MaxMotion

MRS50 COVER

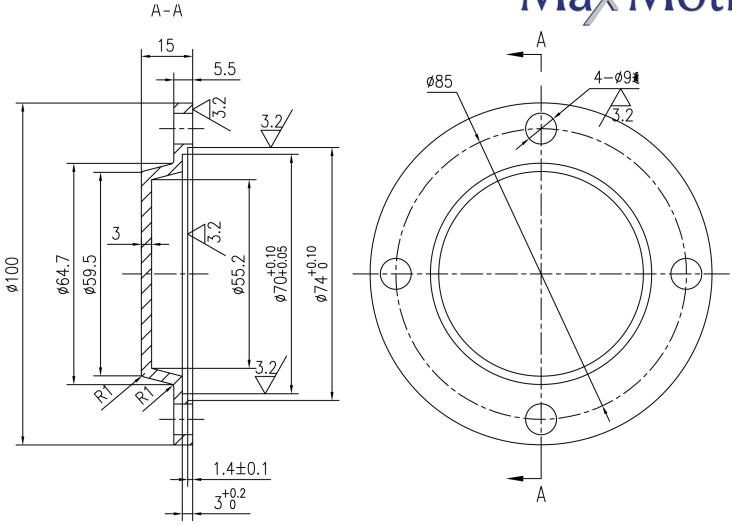
- The cover should incorporate an "0" ring to prevent water.
 The part need to be inclued four outer hexagon bolt.
